Access Compliance Report

Public Rights-of-Way

Intersection ID: 48198	Main Street: RIVERGATE_PY	Cross Street: S_TRYON_ST	Location: SE
ADA ID: AD5A703AE585	Ramp Type: Perp	Initial Pass/Fail: Fail	Overall Compliance: No
		Severity Score: 10

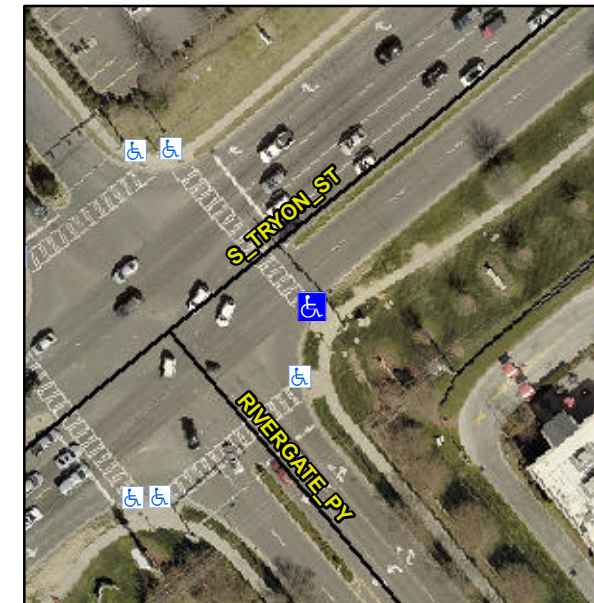
Not Found, R304.5.1, R304.5.3

Compliance	Description	Data	Compliance	Description	Data
N/A	Ramp Length (in)	96.0	Yes	Ramp Slope (%)	8.1
No	Ramp Width (in)	46.0	No	Ramp XSlope (%)	4.3
N/A	Flare Type LT	N/A	N/A	Flare Type RT	N/A
N/A	Flare Slope LT (%)	N/A	N/A	Flare Slope RT (%)	N/A
N/A	Flare Traversable LT?	N/A	N/A	Flare Traversable RT?	N/A
N/A	Landing Length (in)	N/A	N/A	DWS Provided?	N/A
N/A	Landing Width (in)	N/A	N/A	DWS Contrast?	N/A
N/A	Landing Slope (%)	N/A	N/A	DWS Length (in)	N/A
N/A	Landing X Slope (%)	N/A	N/A	DWS Full Width?	N/A
N/A	Landing Curb? (Y/N)	N/A	N/A	DWS Offset (in)	N/A
N/A	Shared Landing?	N/A			
N/A	Gutter Ponding?	N/A	N/A	Gutter Slope (%)	N/A
N/A	Gutter Lip Ht (in)	N/A	N/A	Gutter X Slope (%)	N/A
N/A	Painted X Walk1?	Yes	N/A	Painted X Walk2?	N/A
	X Walk 1 Direction	To N		X Walk 2 Direction	N/A
N/A	X Walk 1 Width (in)	106.0	N/A	X Walk 2 Width (in)	N/A
	X Walk 1 Slope (%)	1.1		X Walk 2 Slope (%)	N/A
	X Walk 1 X Slope (%)	3.3		X Walk 2 X Slope (%)	N/A

Remove & Replace Entire Ramp.
